FIG. 4a

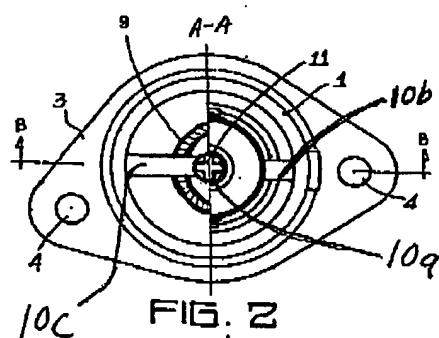
Note how the movement of the working

element 16 pulls down the plate 13 via the connecting vertical blade 23, which compresses the spring 24. It is believed that this view clarifies the operation, and the presence of the vertical blade 23 in original Fig. 4, now 4a cannot be new matter since the blades were present in the original drawing.

Moving to the ring 9, Figure 4(a) also shows

the ring (9), on which one end of the spring rests. This provides a stop for the spring, against which the spring is compressed. To see how this integrates with the converging legs, Fig. 2 in an amended form is now shown. This is a top view, with part of the view cleared of the plate 13, spring, and lower

FIG. 2

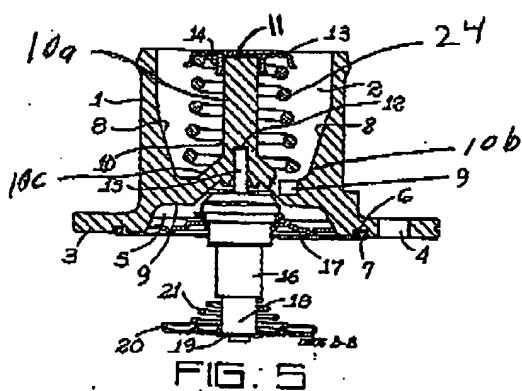
assembly parts. Figure 2 shows how the pair of converging legs (10b) and (10c) lead to the upright portion 10 a. The ring is located within the boundary of the plate 13 since this plate covers the spring which rests on the ring 9. It is evident, that looking along line A-A, one would only see the ends on the ring 9, as pictured above,

the converging leg 10c hidden behind the upright 10a, while when looking along line B-B, the ring would be hidden by the portions 10b and 10 c, since at the intersection of the ring and uprights, they have a common height, to support the spring. This is illustrated in Fig. 5, which has been amended to provide a cut-away, to show the ring 9 as it appears in Fig. 4A, at the same position relative to the working element and spring.
